#### **MEMORANDUM**

**RE:** Updated West Quadrant Plan Minority Reports

# CC 2035 West Quadrant Plan - The Northwest District

# **Building Height Policy – Minority Report**

# **West End**

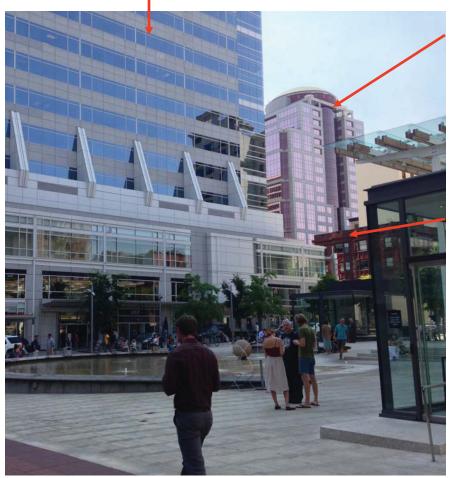
Mr. Pinger's report includes a series of annotated street level views of comparative building heights and street environments for staff and Planning and Sustainability Commission review.

# **Alder and Park**

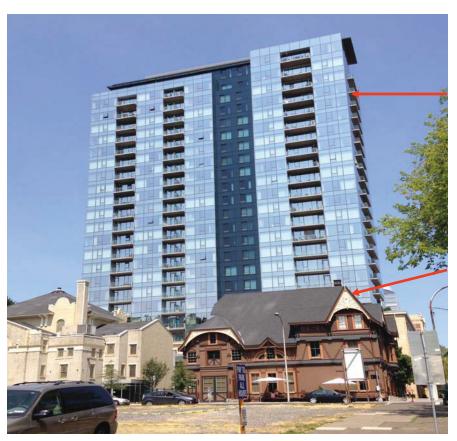
460' allowed

460' proposed
